General Electric Company  
175 Capital Avenue, San Jose, CA 95128

MFN No. 038-92  
Docket No. STN 50-605  
EEN-9224

Subject: **GE Response to Agenda Items Discussed During the GE/NRC  
Reactor Systems Branch Meeting on November 20-21, 1991**

Enclosed are thirty-four (34) copies of the GE response to the subject discussion items, numbered 3,6,7 and 17.

Figure 7-5 FLOW OUT OF VESSEL FOLLOWING A MAIN STEAMLINE  
 BREAK OUTSIDE CONTAINMENT, NO HIGH PRESSURE ECCS AVAILABLE  
 (REALISTIC ANALYSIS ASSUMPTIONS)

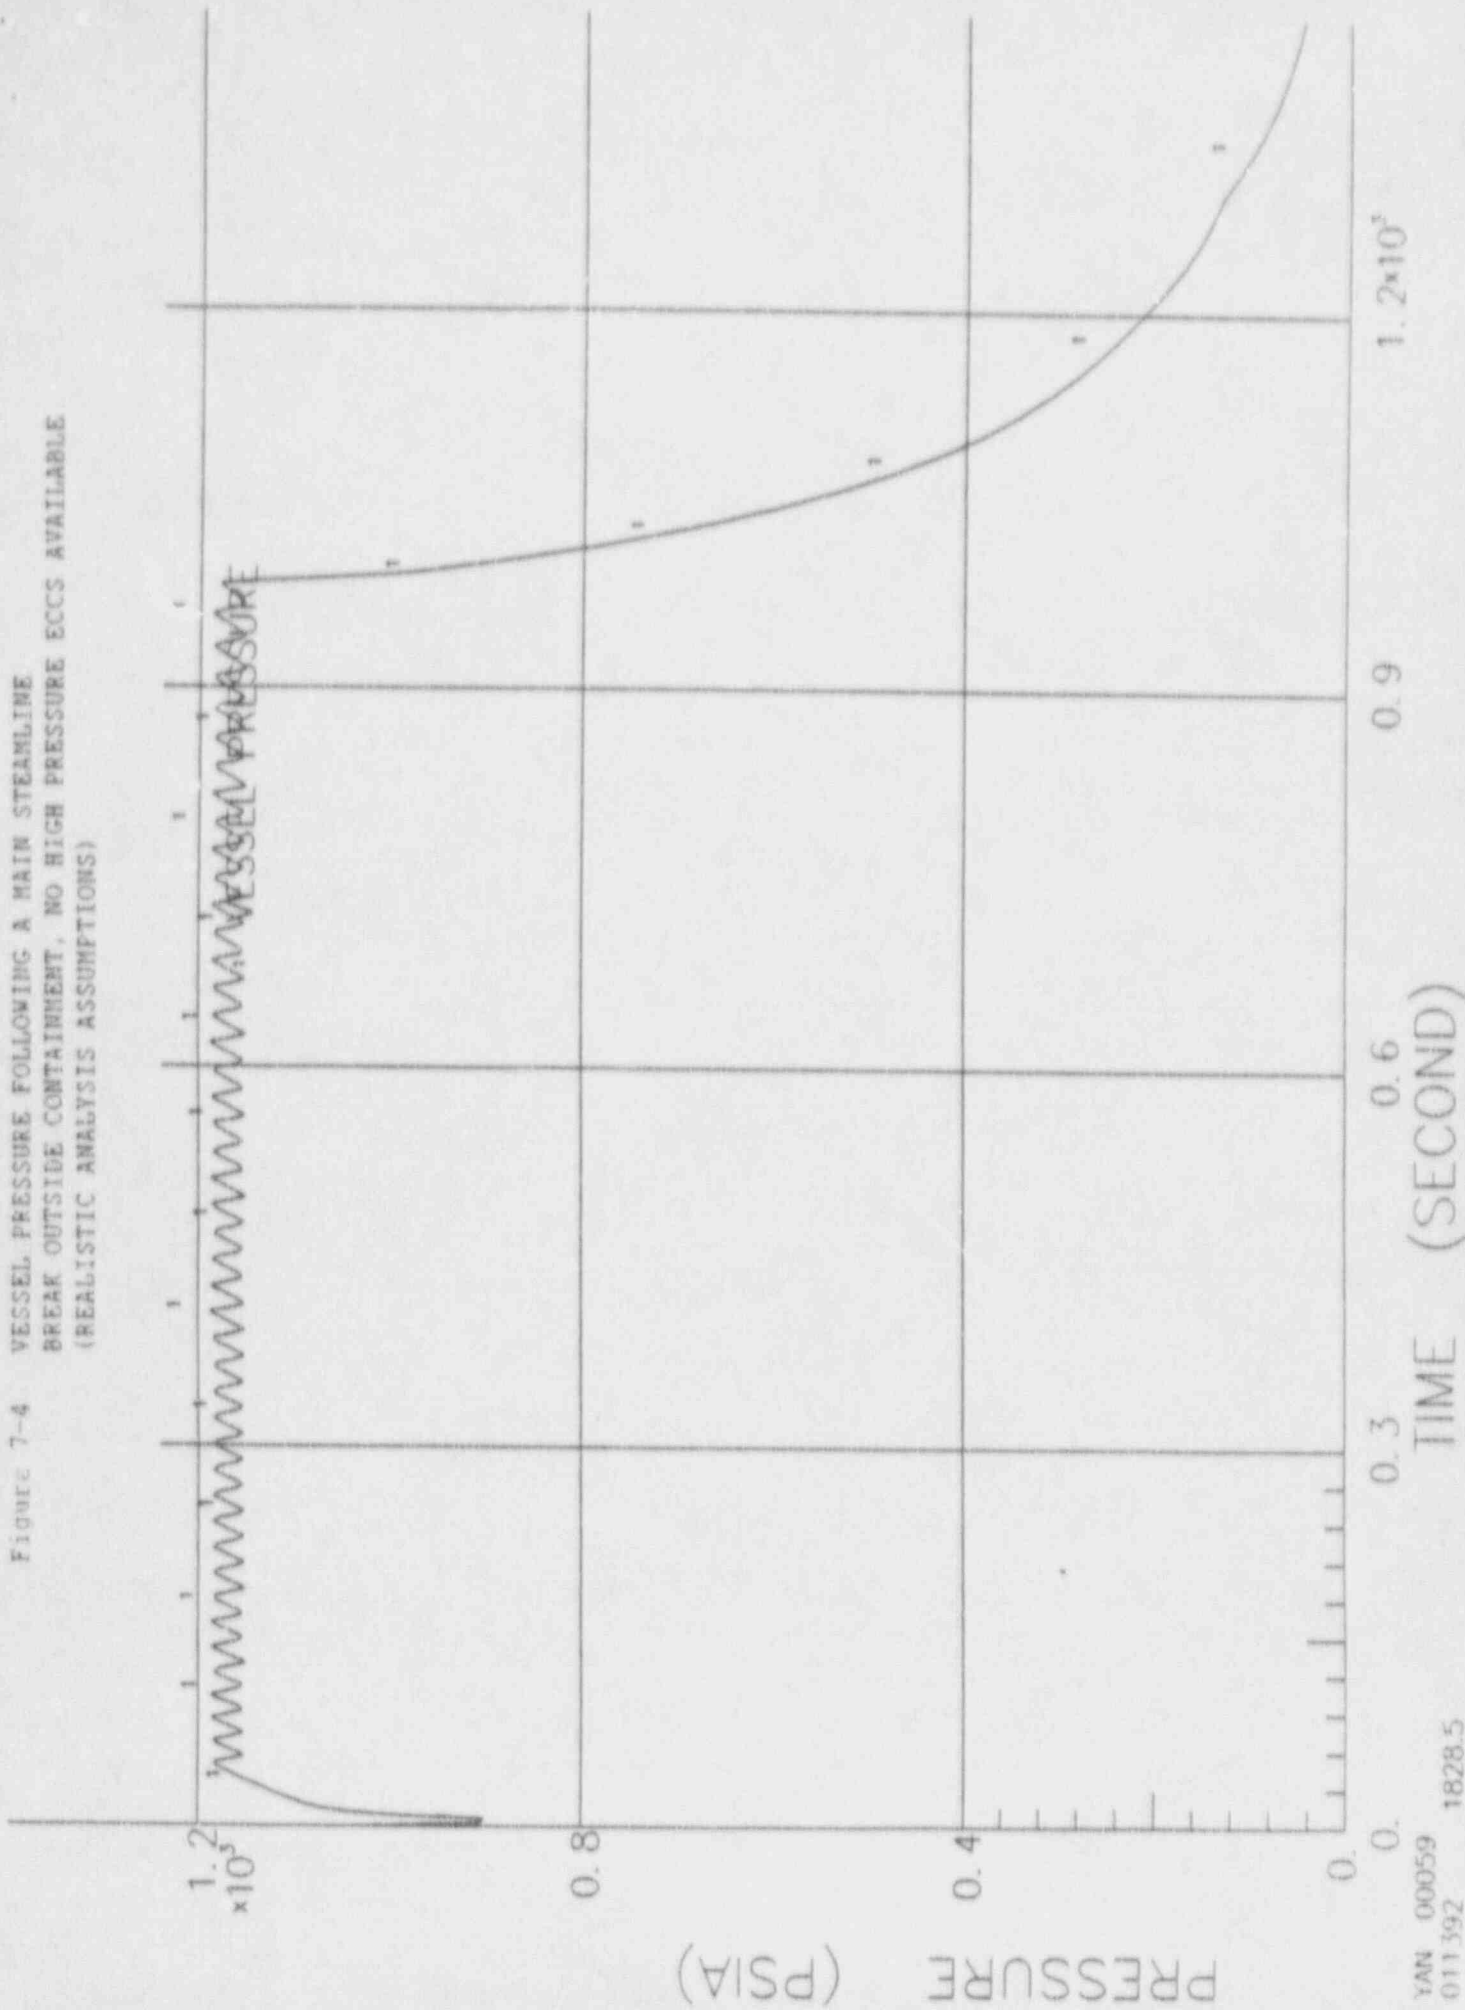
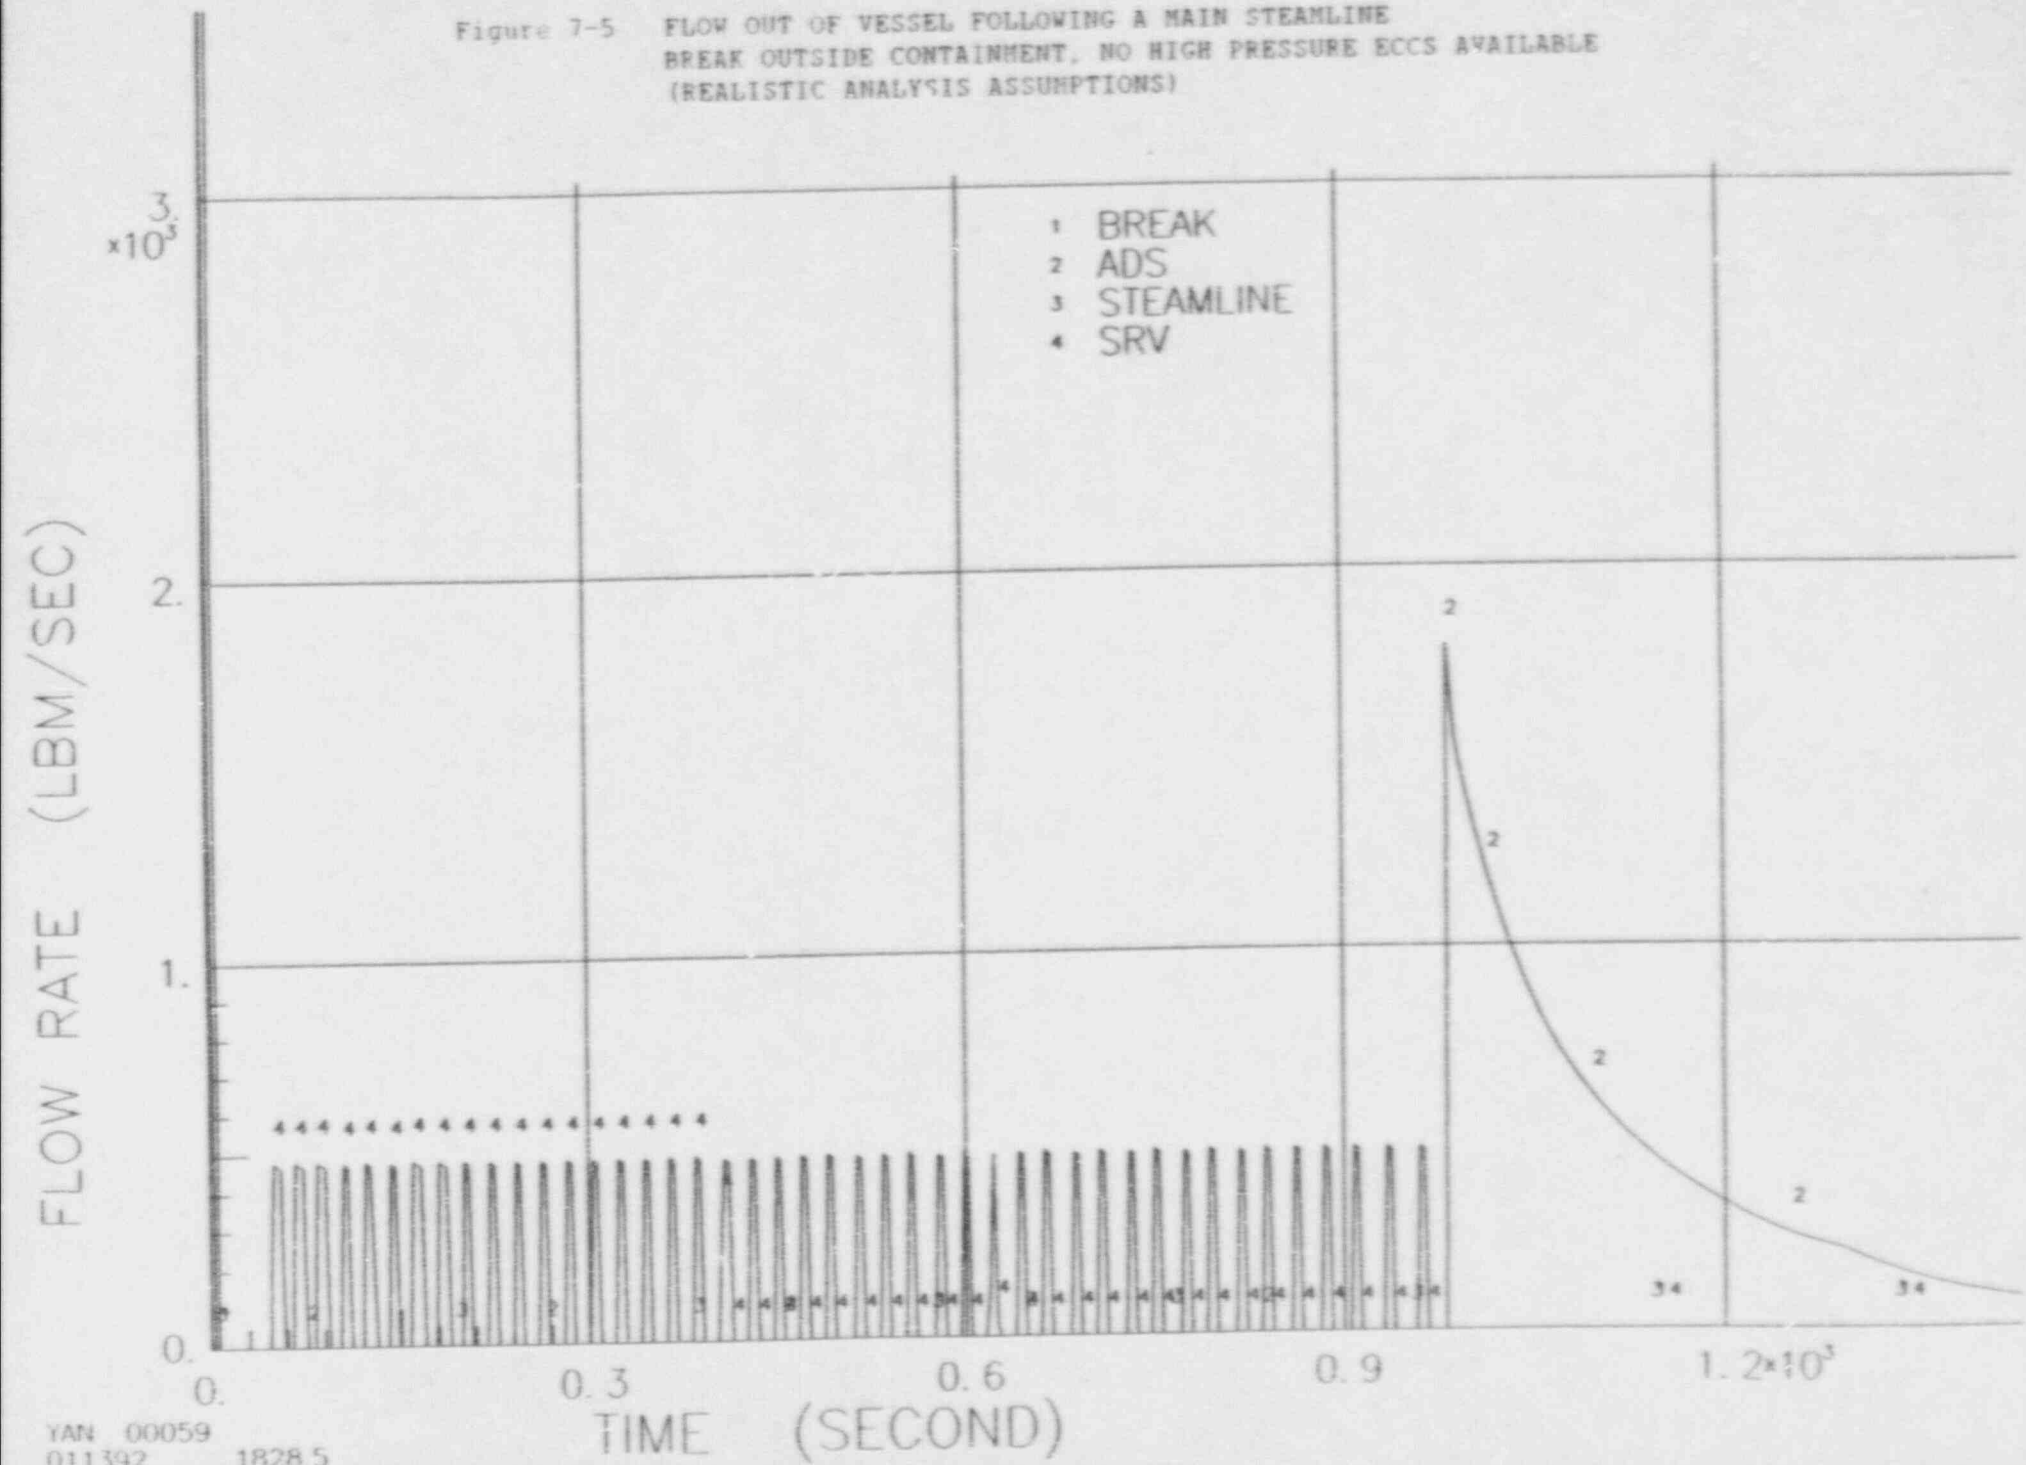
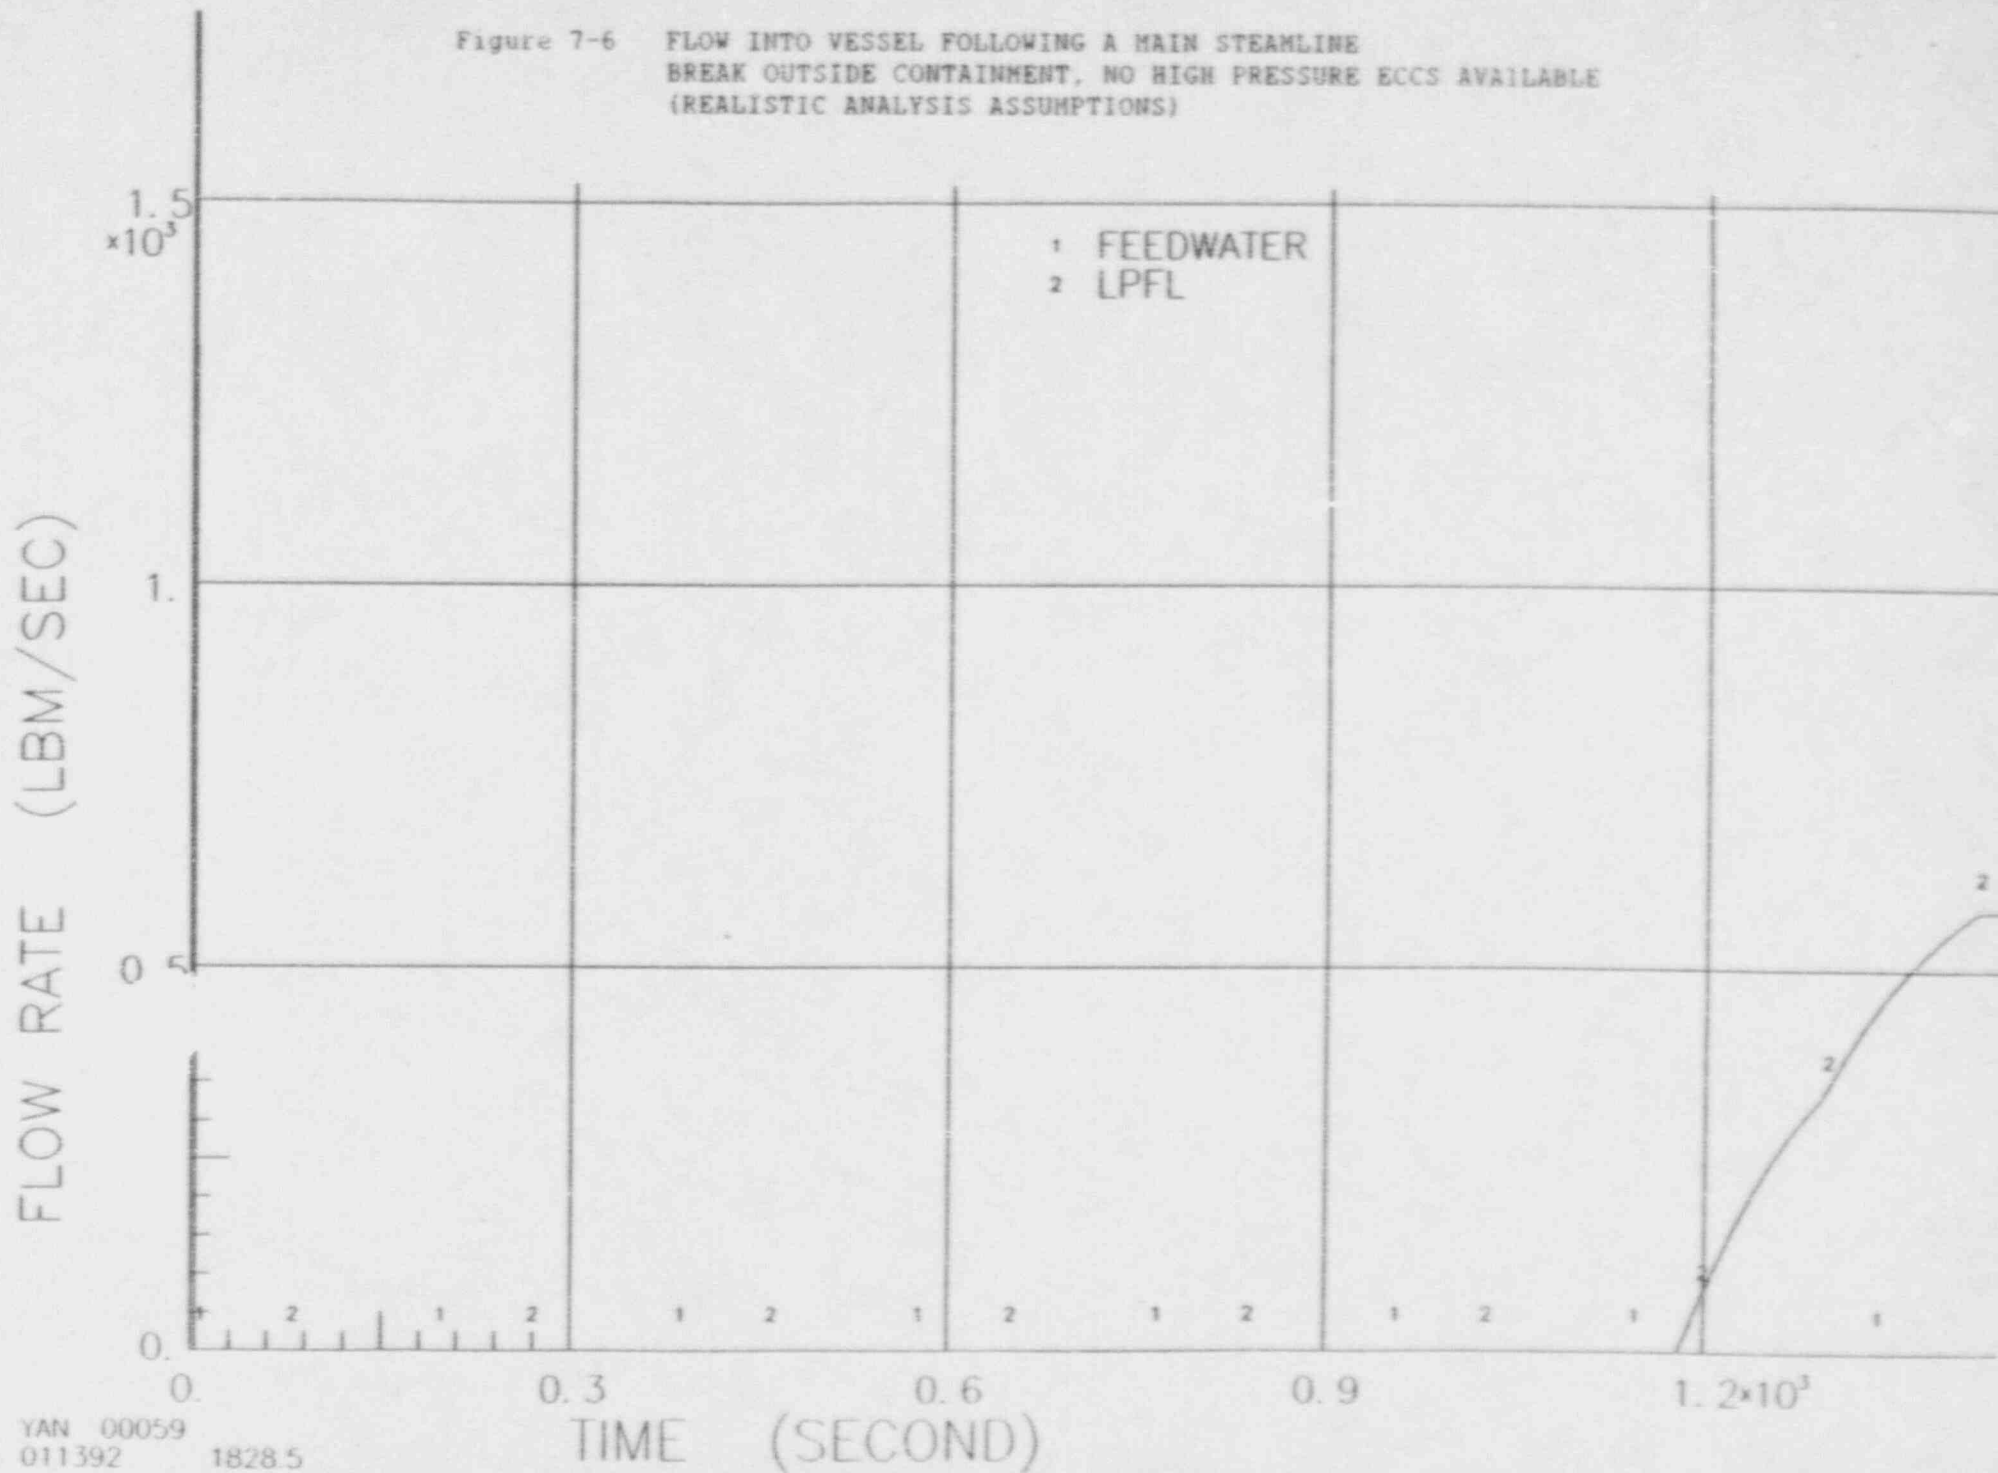
An 8 minute high drywell pressure bypass timer has been added to the ADS initiation logic to address TMI action item II.K.3.18. This timer will initiate on a Low Water Level 1 signal. When it times out, it bypasses the need for a high drywell signal to initiate the standard ADS initiation logic.

For all LOCAs inside the containment, a high drywell signal will be present and ADS will actuate 29 seconds after a Low Water Level 1 signal is reached. All LOCAs outside the containment become rapidly isolated and any one of the three high pressure ECCS can control the water level. The high drywell pressure bypass timer in the ADS initiation logic will only affect the LOCA response if all high pressure ECCS fail following a break outside the containment. For this case the ADS will automatically initiate within 50 seconds (8 minute timer plus 29 second standard ADS logic delay) following a Low Water Level 1 signal.

An analysis was performed to evaluate the adequacy of the 8 minute bypass timer. As discussed above this analysis involves multiple failures. Therefore it is part of the PRA success criteria realistic LOCA evaluation. The main difference between the input assumptions for this case and those in Section 6.3.3 of the SSAR is the use of a realistic decay heat curve (i.e. ANS 5.1). A complete circumferential break of the main steamline outside the containment (which is representative of those LOCA cases where no high drywell signal is present.) was evaluated. The key results from this analysis are given in Figures 7-1 through 7-7. The peak cladding temperature (PCT), refer to Figure 7-7, for this case is less than 1100°F which is well below the 2200 °F licensing limit. This PCT is due to the initial voiding in the core at the beginning of the event as in the case of the design basis evaluation. The heatup caused by the core uncover late in the event is negligible. These results confirm the acceptability of the 8 minute high drywell pressure bypass timer.
